**To:** Administrative File BL STN 125644/0.30 (DATS# 716008) for Human Albumin Solution 5% and 25%

**Subject:** Responses to Complete Response Review Memo Bio Product Laboratory Ltd. (BPL) (US License #1811) - Biologics License Application (BLA) for the Manufacture of Human Albumin Solution 5% and 25% at Their Hertfordshire Facility in the United Kingdom

**ADD:** June 19, 2018

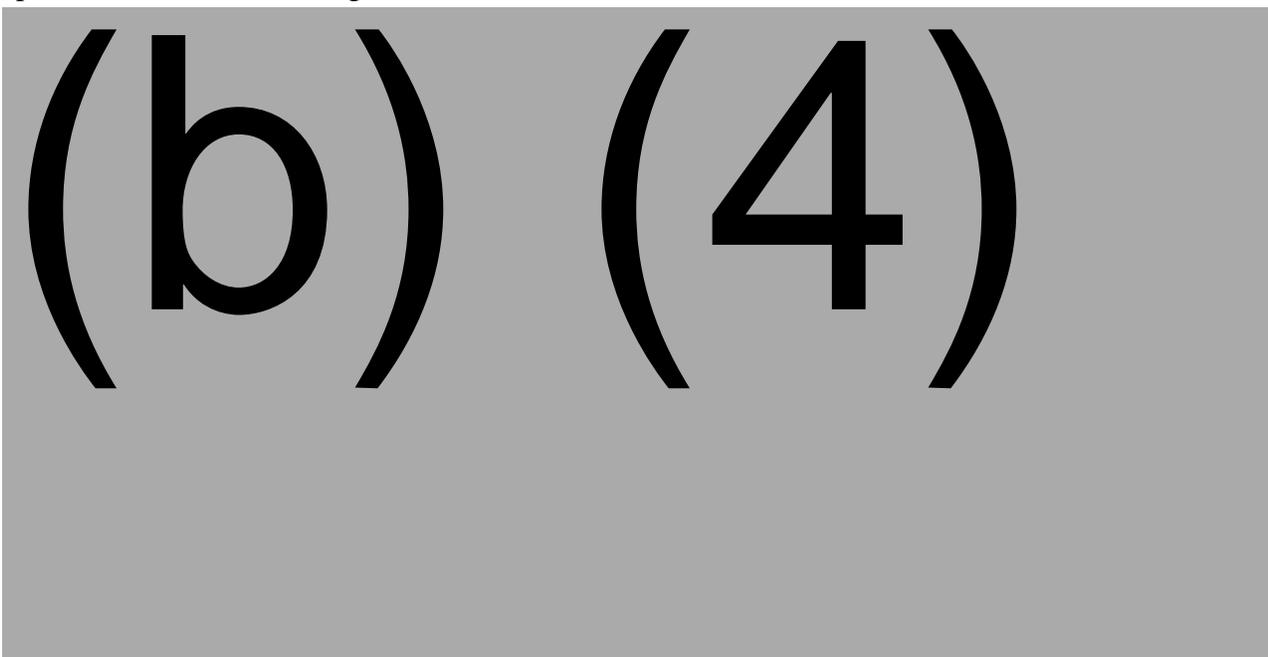
*b. In addition, you conducted Environmental Monitoring (EM) during the filling step. However, the results from these testing and the EM were not documented in this form. Please explain the reason to not documenting the EM results from the filling step on this form. Please provide the EM results during the filling step for these lots.*

**Firm Response:** BPL provided the EM results; in addition, to the sampling locations with their respective action limits in support for the filling of Lots (b) (4). They indicated that the sampling locations and action limit for the EM during filling processes are the following:

BPL provided copy of QBT/00853/03/FRM, which describes the EM sampling locations in the filling room (b) (4), which are applicable to the filling of all the PPQ lots in support for this application.

The firm provided the EM results from Lots (b) (4). They indicated that all viable particulate count and personnel monitoring and non-viable particulate count results from these lots did not exceed the above action limit.

**CBER Comments:** The EM results from the filling of Lots (b) (4) in support for this BLA were reviewed and found acceptable.
